CITY OF ALBUQUERQUE

RE: **Catalonia Subdivision**
Tr 1 & 2, The Trails Unit 3A
Drainage Report Stamp Date: 7/11/19
Grading Plan Stamp Date: 7/11/19
Hydrology File: C09D013

July 11, 2019

RE: **Catalonia Subdivision**
Tr 1 & 2, The Trails Unit 3A
Drainage Report Stamp Date: 3/29/19
Grading Plan Stamp Date: 3/29/19
Hydrology File: C09D013

POND B TO POND A5

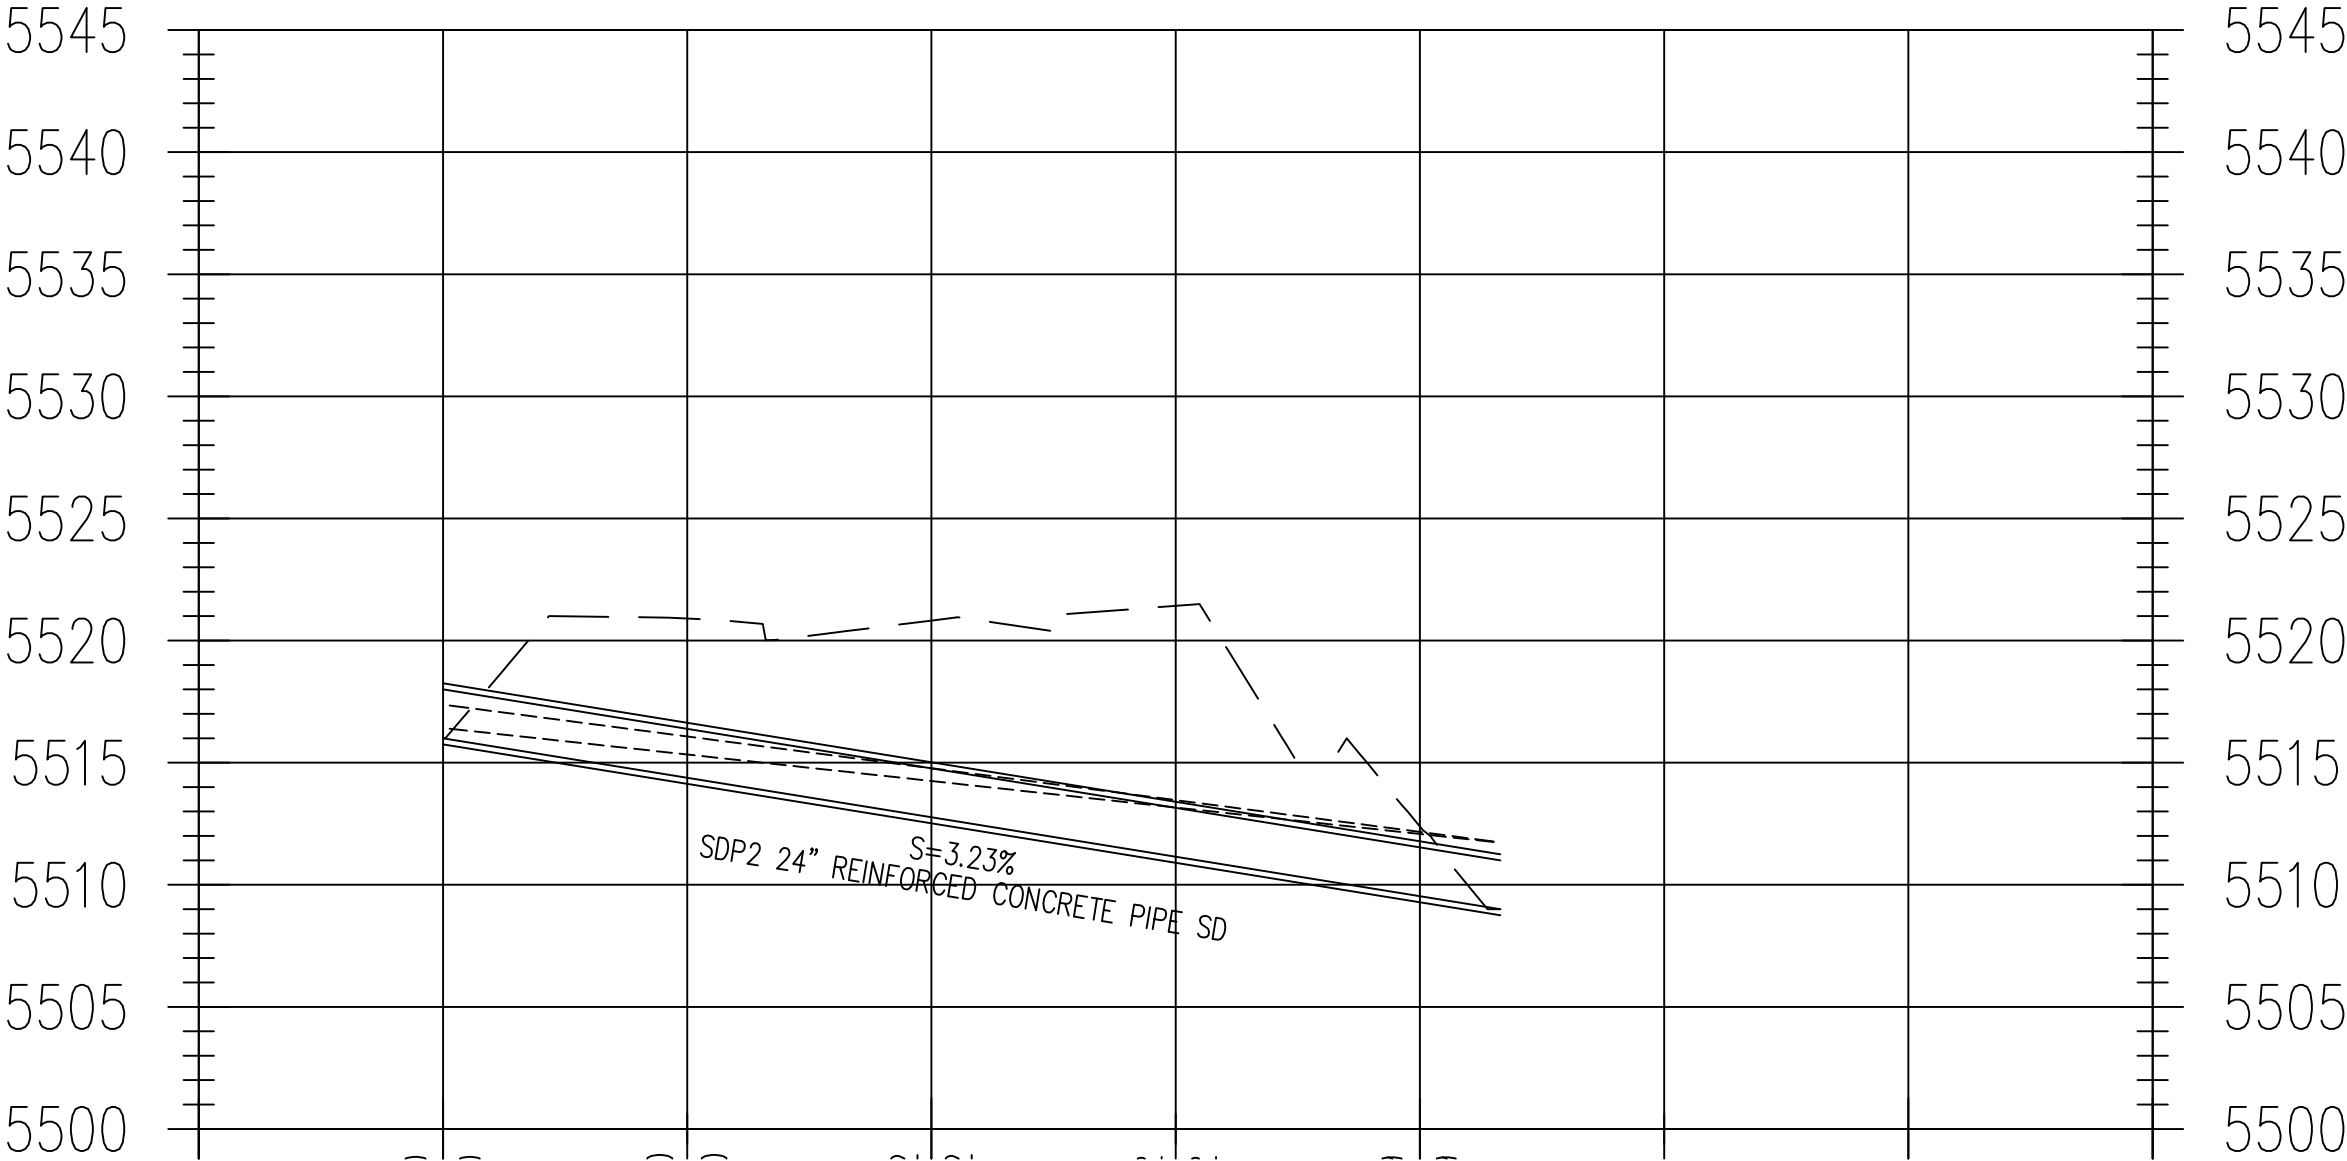
2. Pond Routing.
 - a. Pond B outlet needs to be revised in HMS to show an orifice plate that will restrict discharge to 3.36cfs max. The headwall into 6" culvert under Woodmont won't be acceptable; minimum pipe size is 24" as is correctly shown on the infrastructure list.

EXHIBIT F:
GRADING PLAN

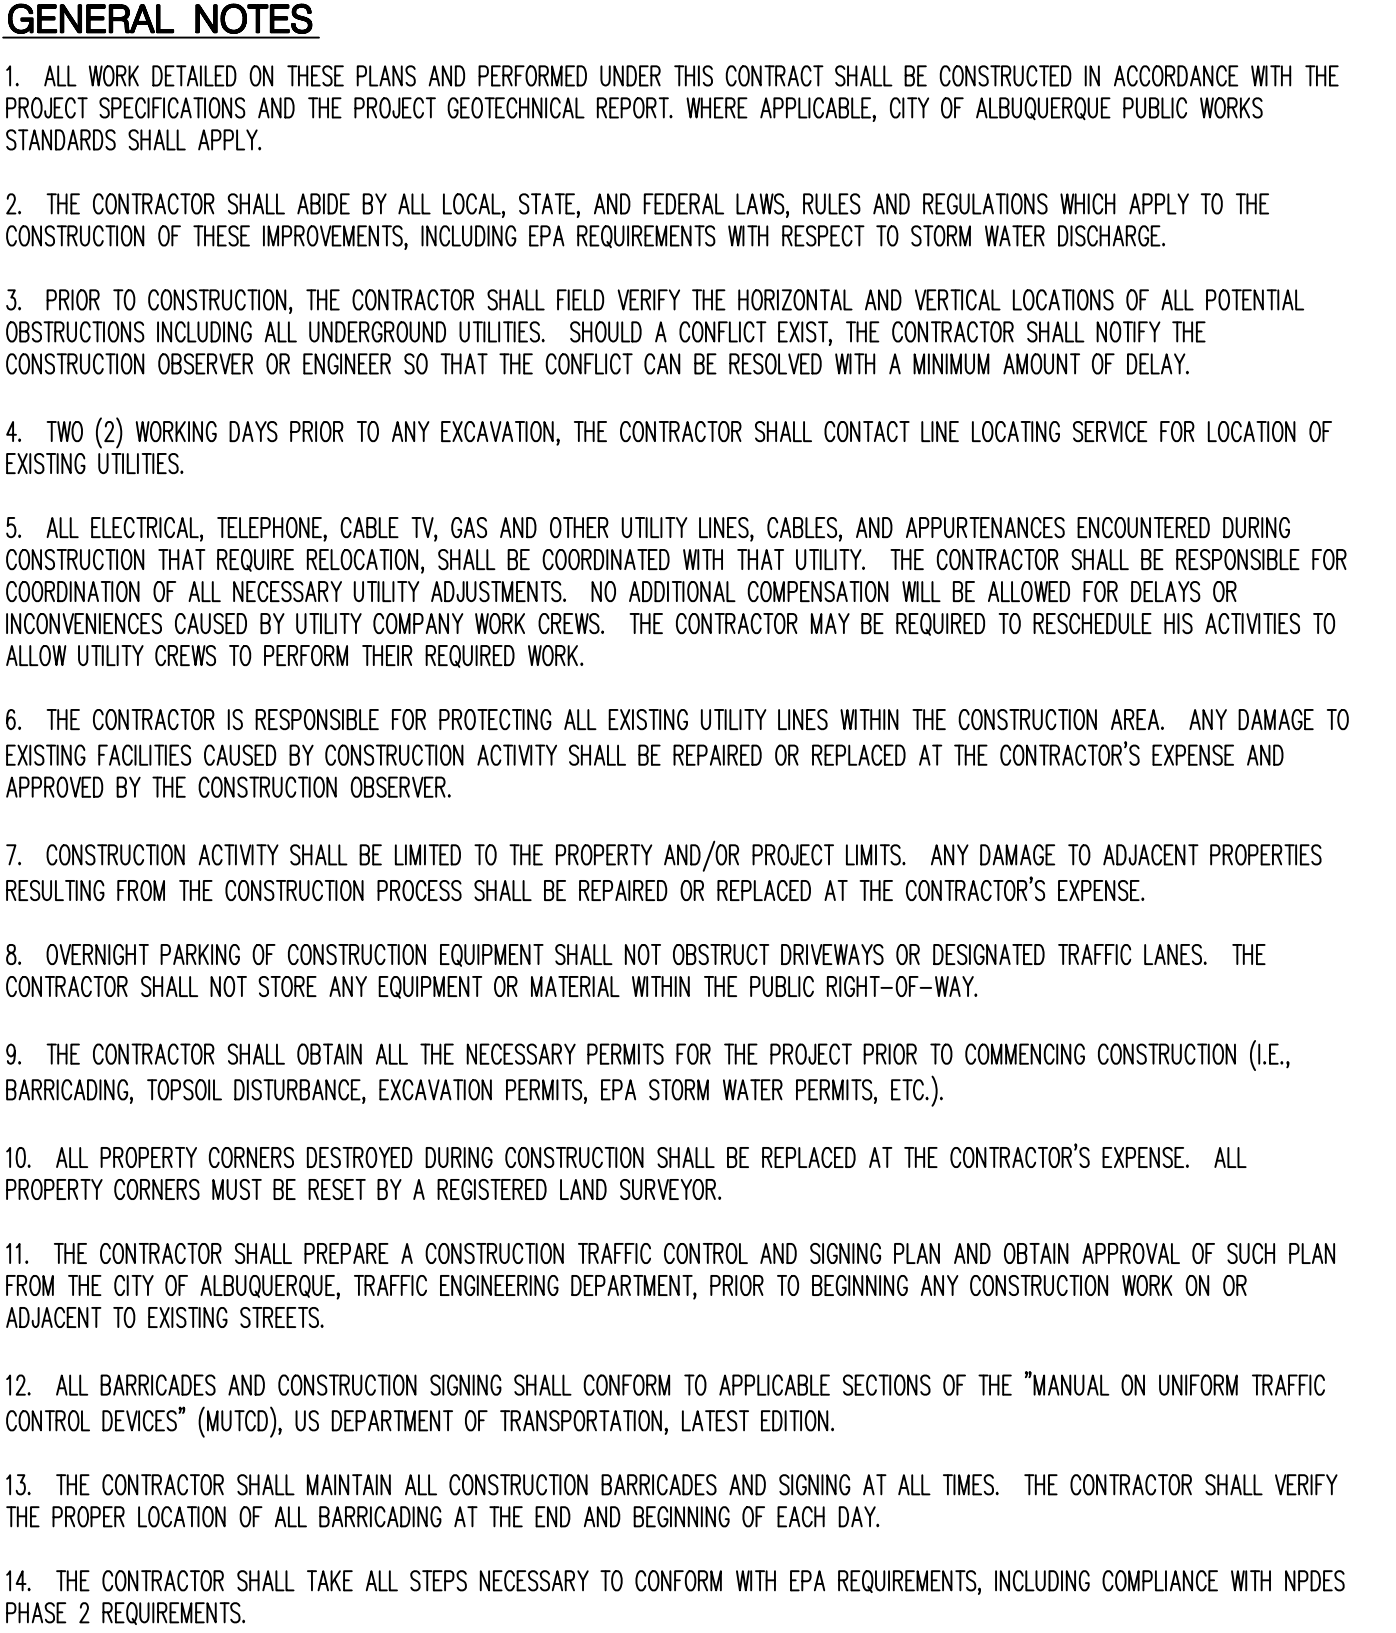
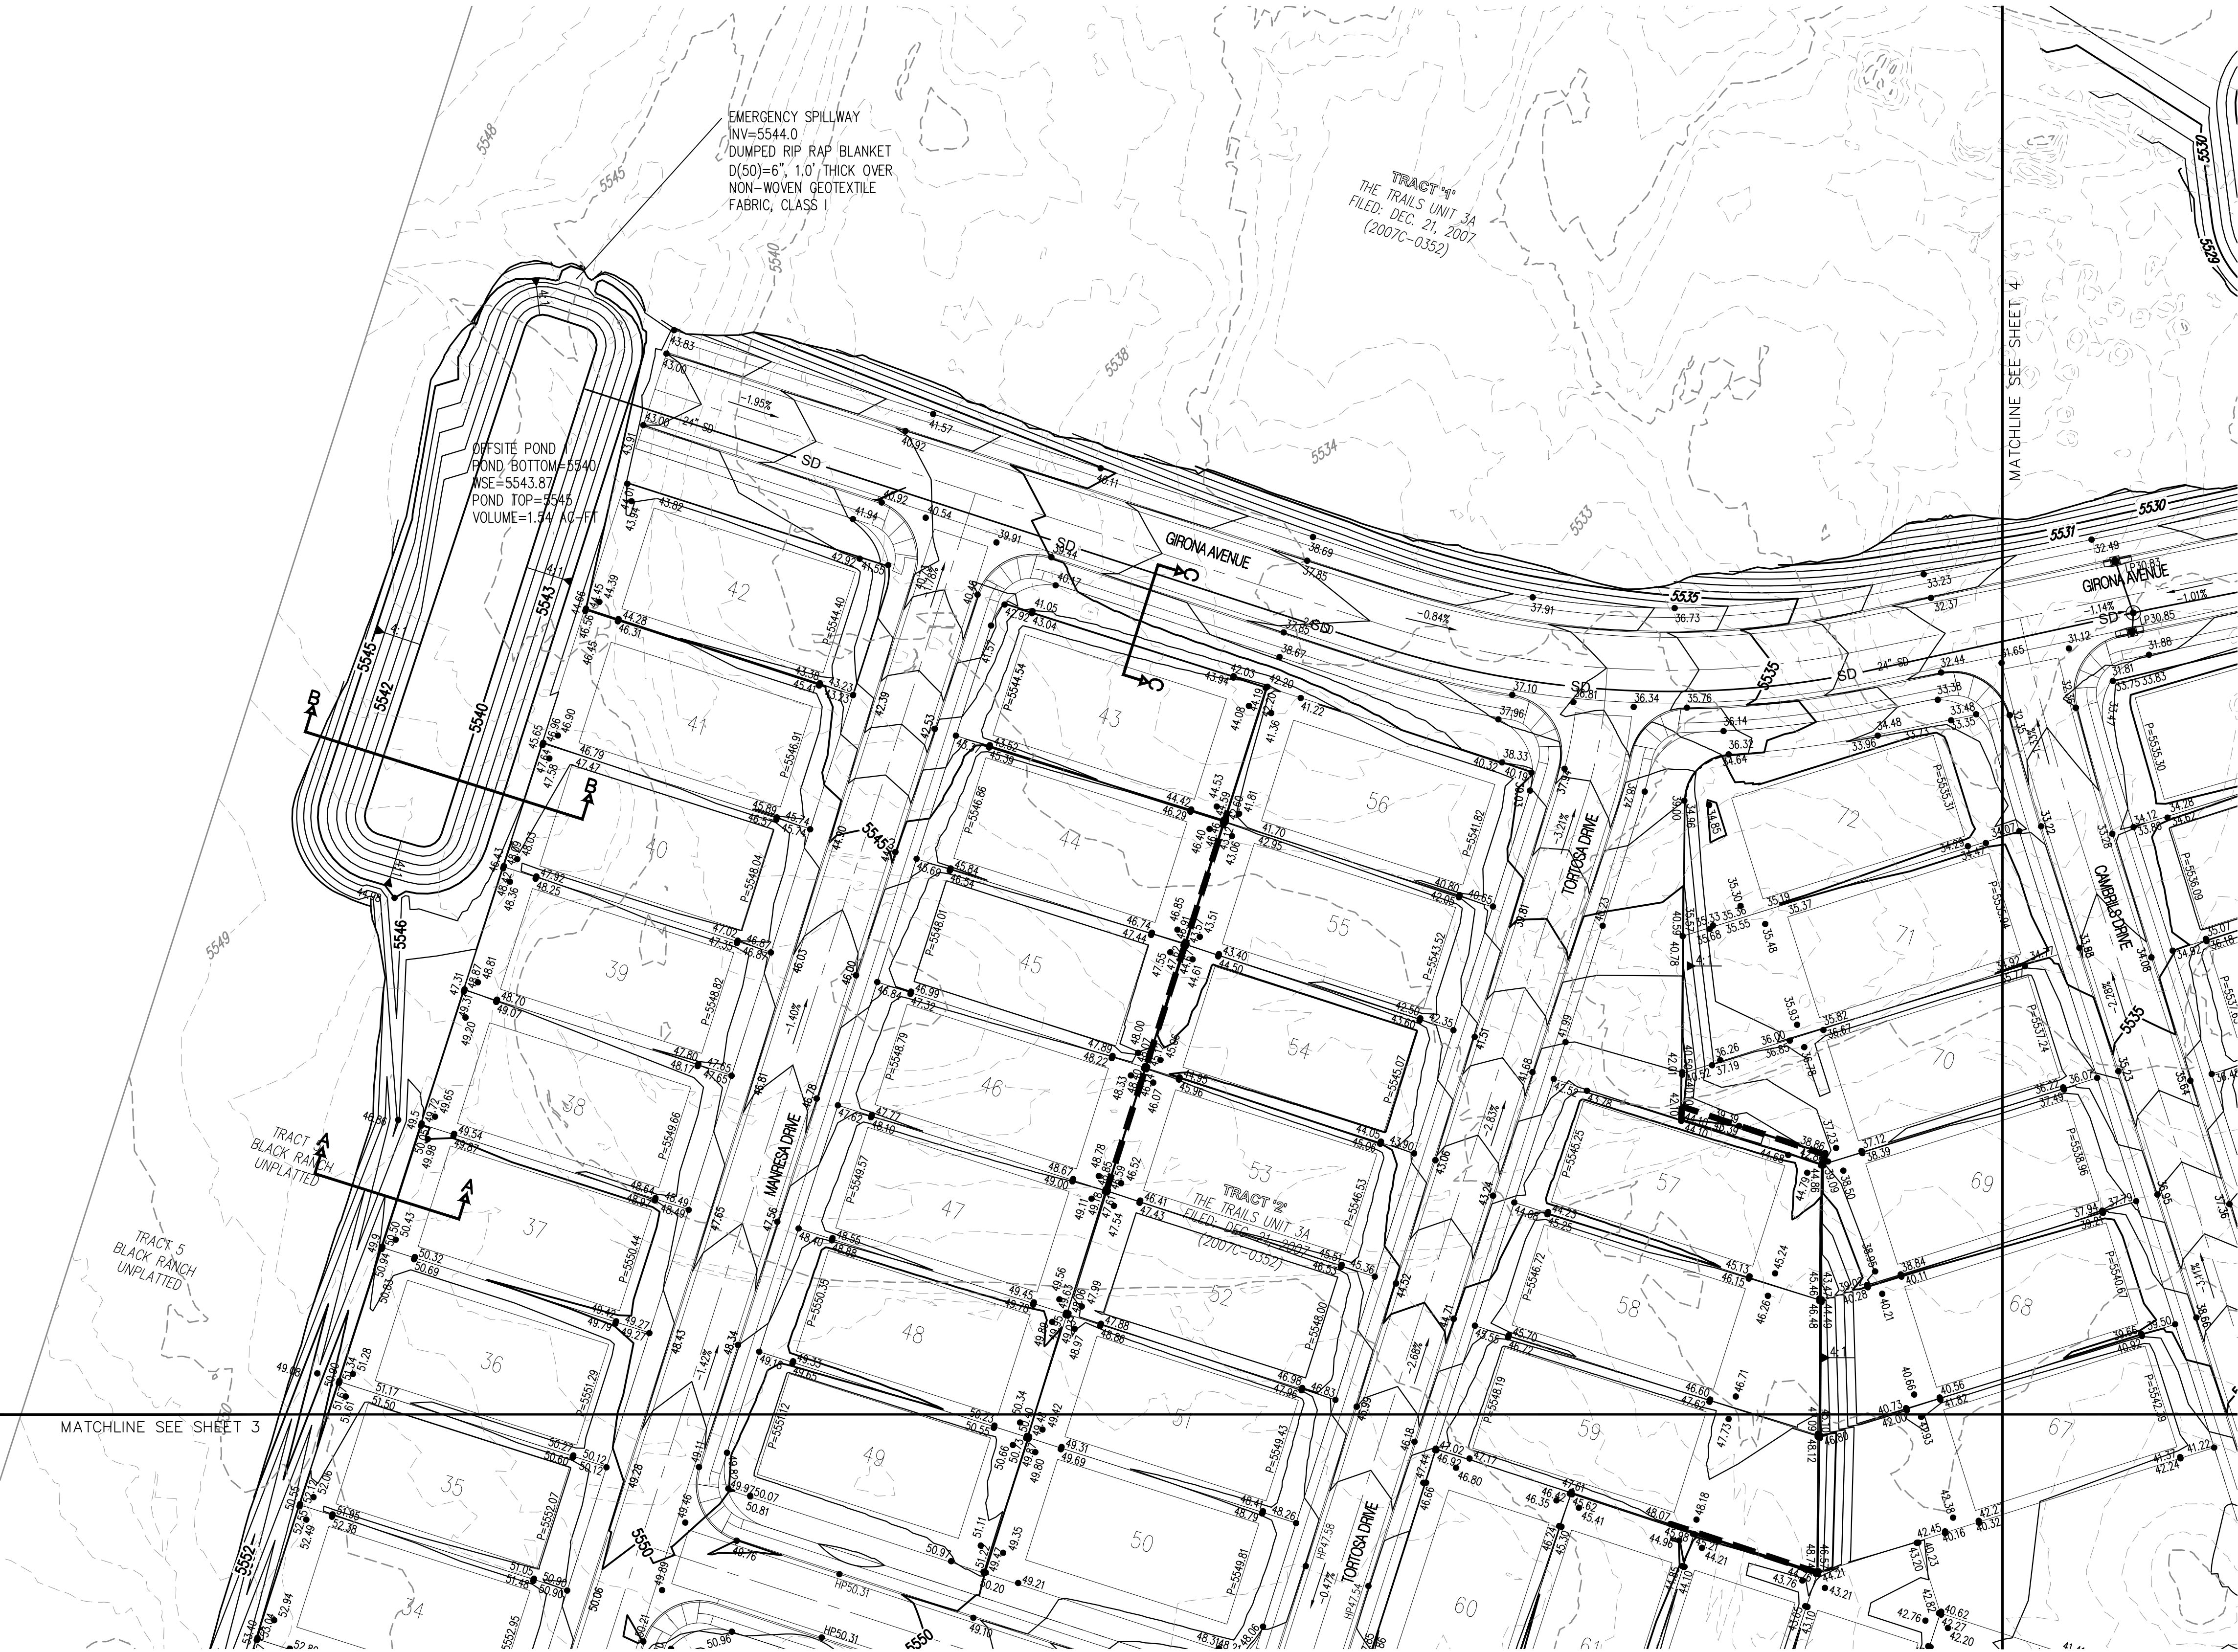
- b. Show and label the 100-yr WSE and SWQV elevation of each pond on the grading plan.
3. Storm Water Quality (SWQ). Use of Retention Pond A5 and Pond A for retaining the SWQV acceptable provided that the SWQ volume and SWQ water surface elevations are called out on the plans and in the maintenance covenants. The SWQ retention within these ponds will be permanent.

4. Please look at the Cambrils Dr assembly/section in front of lots 1-5. The contours seem to show an inverted crown with an odd transition in front of lot 6.

8. Provide dimensional data on plans (top width, bottom width, depth, etc.) for the spillways and swale.
